TITLE: Review and action of a Subdivision Permit and Plat for Carpenter Pump Station, 1st Filing, a portion of land located in the SW1/4 NW1/4, Section 35, T.13N., R.63W., of the 6th P.M., Laramie County, WY.

Carpenter Pump Stn Subdivision Permit and Plat

PZ-19-00043

PZ-19-00043 CARPENTER PUMP STATION, 1ST FILING
SUBDIVISION PERMIT & PLAT

SUBDIVISION PLAT

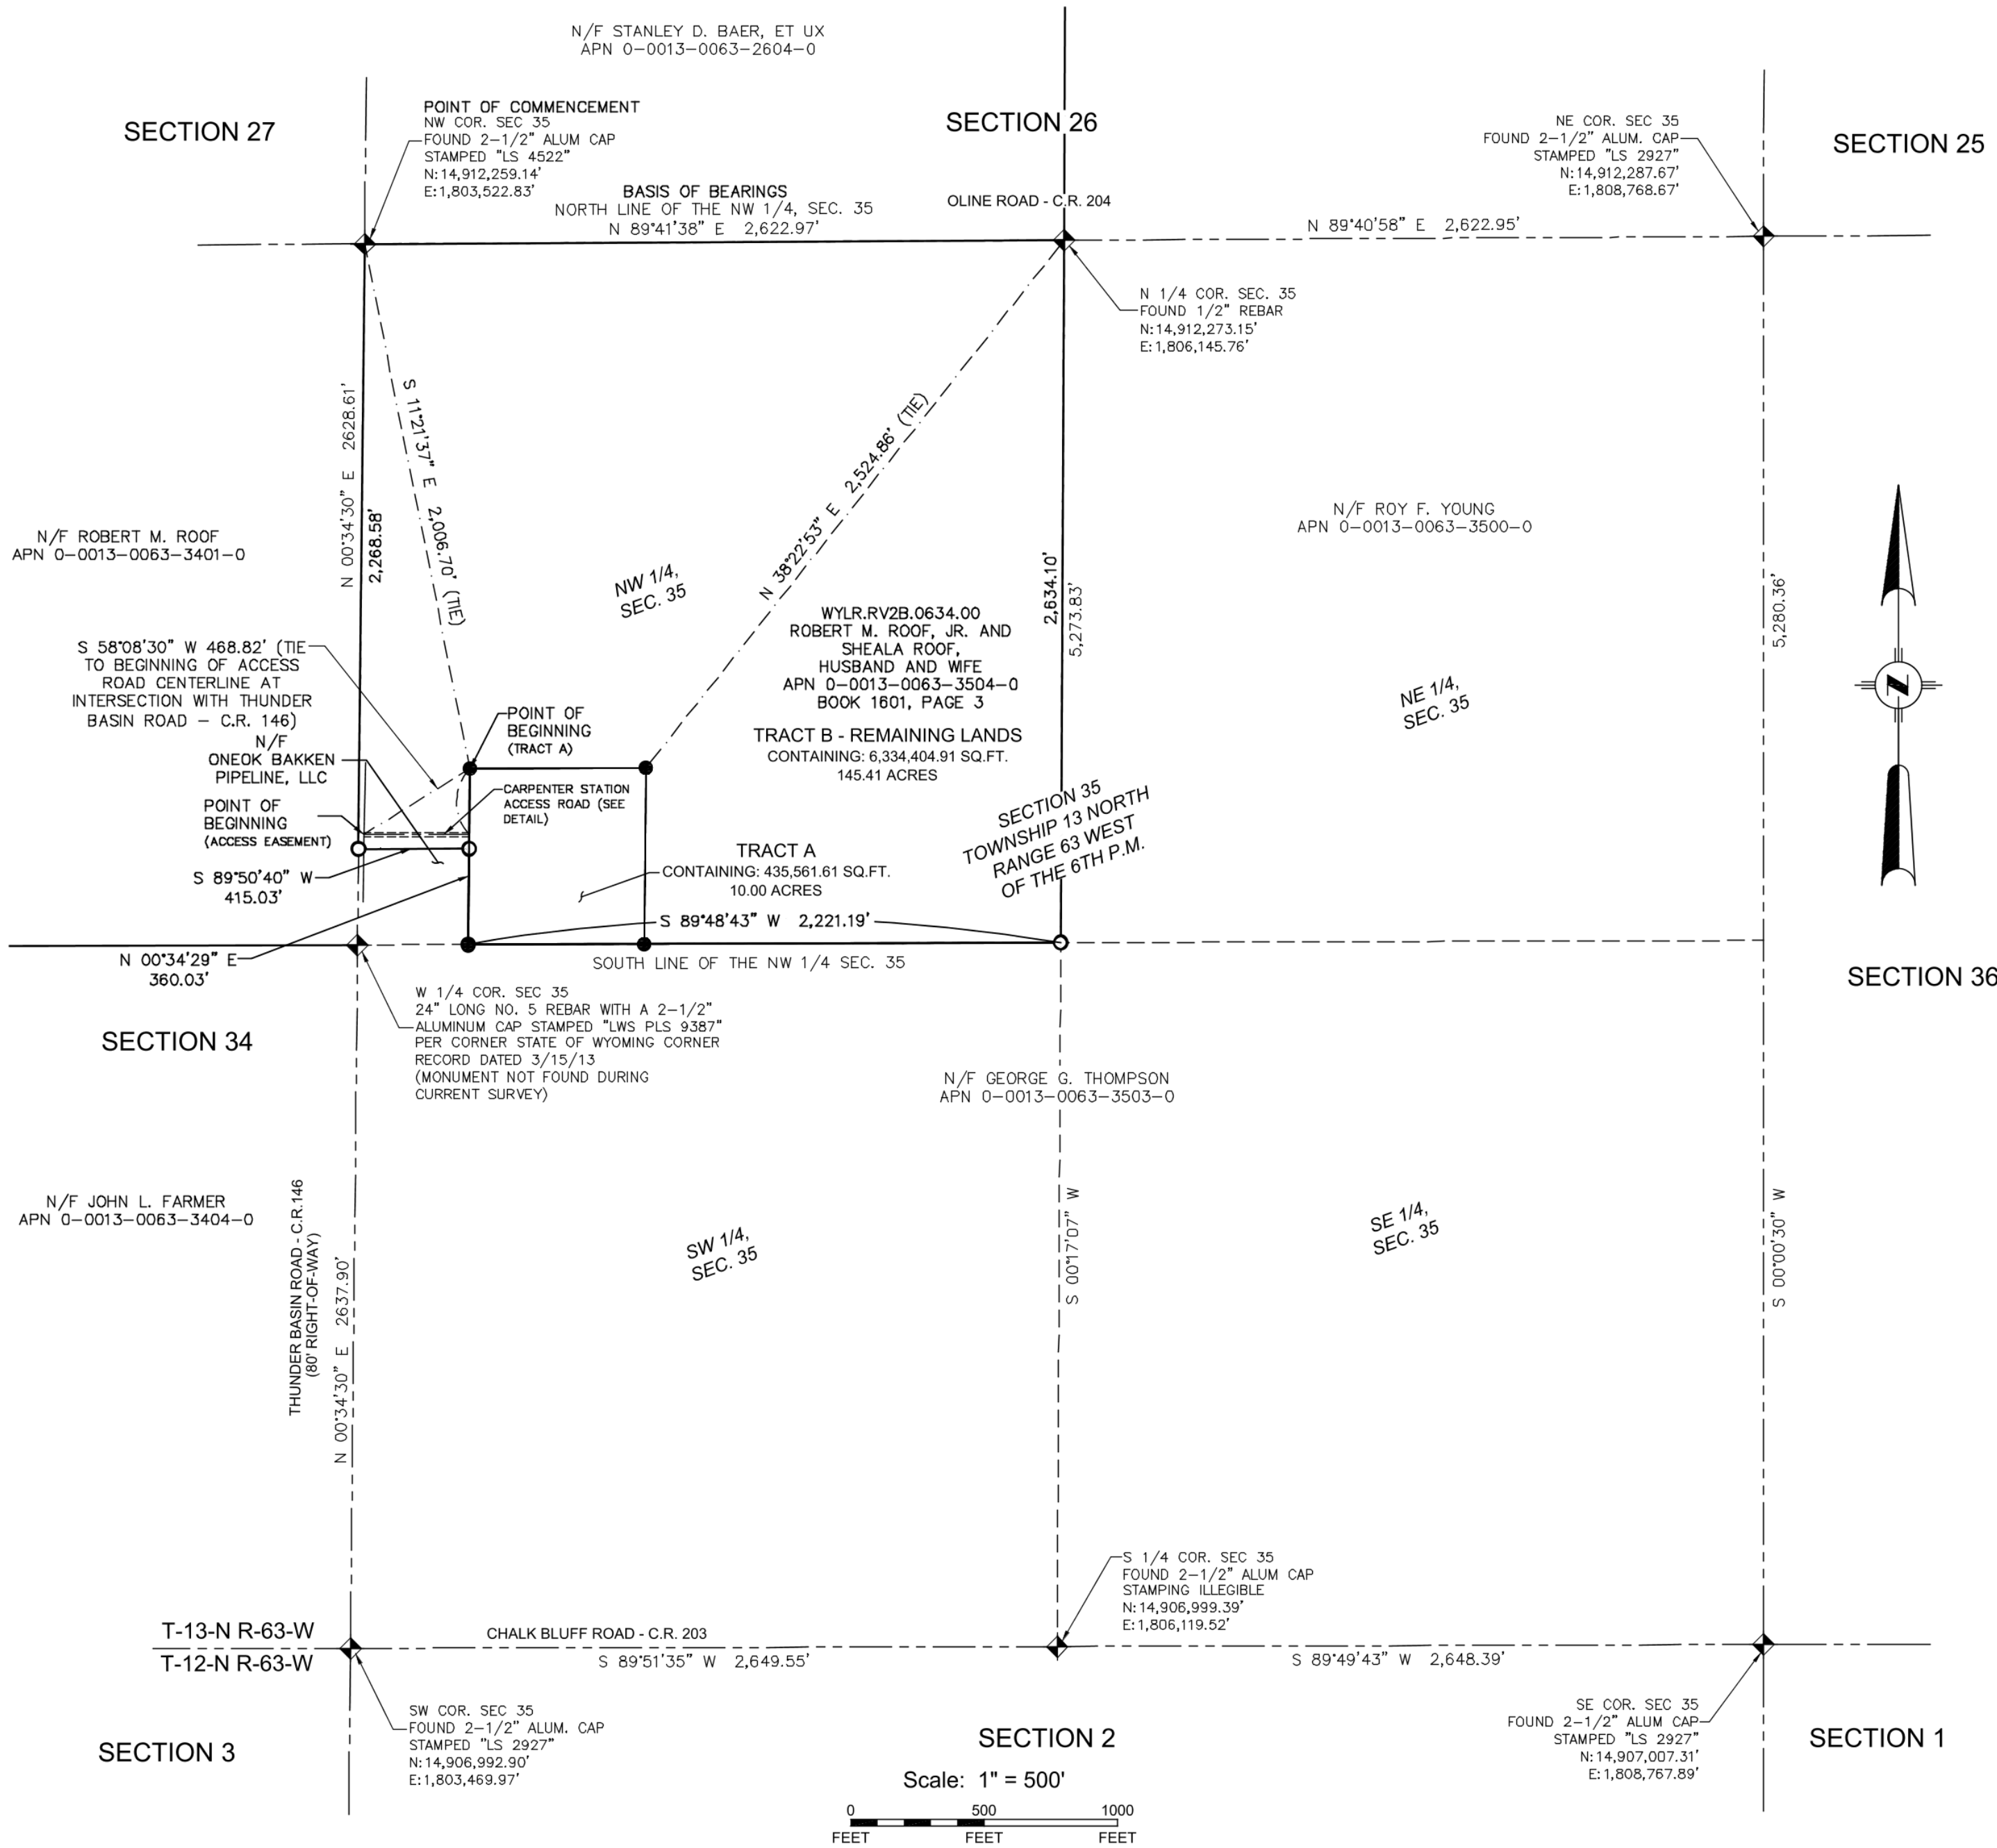
1. The Plat needs to include the type of sewage disposal, water supply, and which Fire District serves this site for fire protection.
2. I concur with the request for a waiver of a detailed Drainage Study and Traffic Study at this time. As indicated in the request, those items will be submitted, as needed, with the Site Plan application.
3. The width of Thunder Basin Road -- CR 146 is not shown on the plat.
4. There is no signature blocks for the Planning Commission, Chairman of the Board, property owners, etc. on the plat drawing.

1. There are no DEDICATION or ACKNOWLEDGEMENT STATEMENTS shown on the Subdivision Plat.
2. In the SURVEYOR'S CERTIFICATE "THE ATTACHED CERTIFICATE OF SURVEY REPRESENTS..." needs to be changed to "THE ATTACHED PLAT REPRESENTS..." and "THIS CERTIFICATE OF SURVEY IS TRUE TO..." needs to be changed to "ALL INFORMATION SHOWN IS CORRECT TO..."

3. The nearest public land survey system monument is the West One Quarter (1/4) Corner of Section 35, which is not described on the Subdivision Plat.
4. The closing course in the subdivision legal description is not labeled on the drawing of the Subdivision Plat.

5. It does not seem necessary that the 16' Access Easement serving Tract A extend into Tract A approximately 8531' of the east-west width of Tract A.
6. The Vicinity Map would be easier to read and it would be more useful to the 'lay public' if one were to add some information such as, at a minimum, the Section, Township and Range data with enough detail to indicate the location of the subdivision within the Section.

7. Some of the GENERAL NOTES seem to be applicable specifically to an ALTA SURVEY, not a SUBDIVISION PLAT. Note 1 is definitely not appropriate or correct for a FINAL SUBDIVISION PLAT. Notes 2, 5, 6, 7, and 9 are not relative on a FINAL SUBDIVISION PLAT. Note 8 is confusing as written, may not be necessary on a FINAL SUBDIVISION PLAT.

1. The proposed plat is missing necessary criteria to be shown on the Plat, per Section 2-1-101(e) of the LCLUR.
2. There are no notes addressing sewage and water, or the serving County Fire District.
3. Signature blocks are needed for the approving parties.
4. Utilities need to be removed from the plat. Only property, R/W, and easement lines should be shown.
